Interactive comment on “Runoff formation from plot, field, to small catchment with shallow groundwater table and dense drainage system in agricultural North Huaihe River Plain, China” by S. Han et al.

S. Han et al.

Received and published: 20 June 2012

Interactive comment on *Hydrol. Earth Syst. Sci. Discuss.*, 9, 4235, 2012.

Fig. 1. Figure R1. Relationship between estimated available water storage and initial water table depth

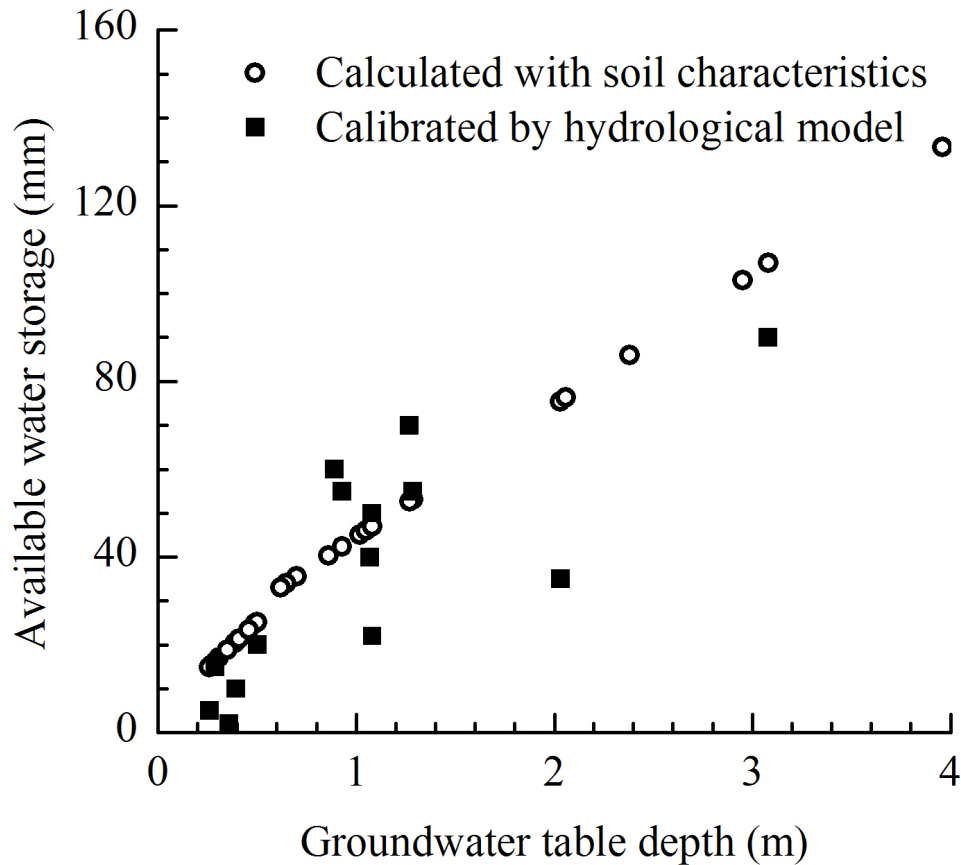
1. The paper should stress out that groundwater table as a wetness indicator is a

proxy only to the soil moisture status. Rough estimation of the available water storage towards the accumulation availability of the water in the vadose zone is advised based on simple tools as retention curve derived e.g. from particle size properties assuming equilibrium distribution of the soil water content along vertical axis, if measured data are not available.

It is a helpful advice to calculate the available water storage before each event. But the relationship between the water table depth and soil moisture dynamics is complicated. In order to give a roughly comparison, the differences between saturation water content and field capacity was used to calculate the available water storage. In the study area, the soil was divided into three layers according to its characteristics: 0~20cm with saturation water content and field capacity 39.6% and 30.7%; 20~50cm with saturation water content and field capacity 30.1% and 25.8%; 50cm~400cm with saturation water content and field capacity 28.1% and 25%. The plots of calculated available water storage and water table depth are shown in Figure R1.

At present, the Xinanjiang model (a lumped conceptual rainfall–runoff model) (Zhao, 1992) was used to simulate the storm-runoff processes of 14 events at the catchment with calibrated parameters (including averaged soil moisture storage capacity of three layers) and antecedent soil moisture content. The performances of the model were acceptable (with Nash-Sutcliffe efficiency around 0.7). The difference between averaged soil moisture storage capacity and antecedent soil moisture content can be served as available water storage. And it was also plotted against the water table depth of the 14 events in the figure.

Although the calculation at present is not very precise, it is obvious that available water storage is closely correlated with initial groundwater table depth. Groundwater table can be served as a wetness indicator. In the revised manuscript, we will state clearly that the groundwater table data is served as a proxy to the soil moisture status. We will continue the study on the relationship between groundwater table and soil moisture status.
